曜凌光電股份有限公司 Raystar Optronics, Inc.

Issue Date: August 29, 2022

Product Change Notification

Module Drawing Comparison

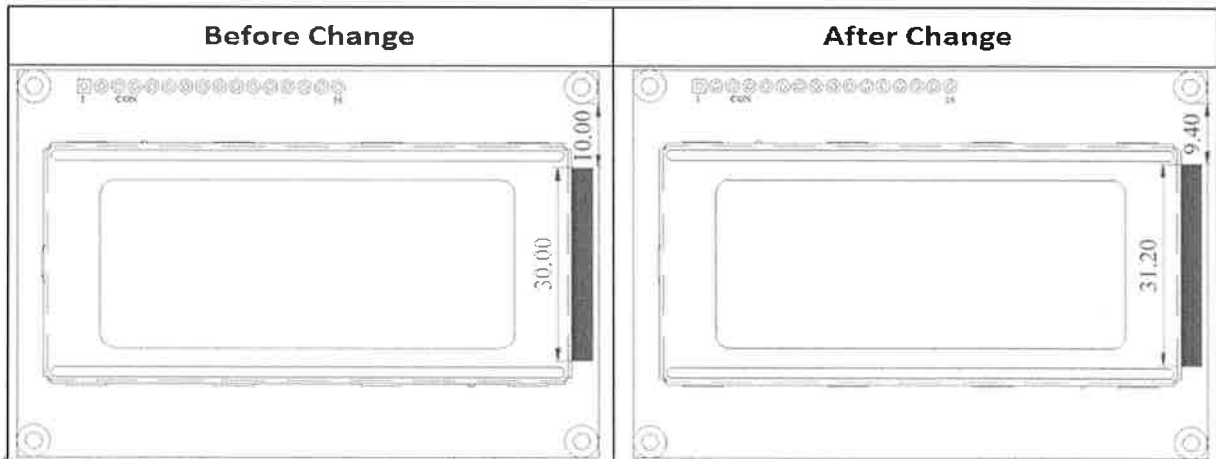
- Description: In order to improve production efficiency and yield, and more in line with the in-house process, the following backlight optimization changes will be made.
- Description of change: The width of the backlight protruding metal frame is increased from 30mm to 31.2mm
- Effected model:
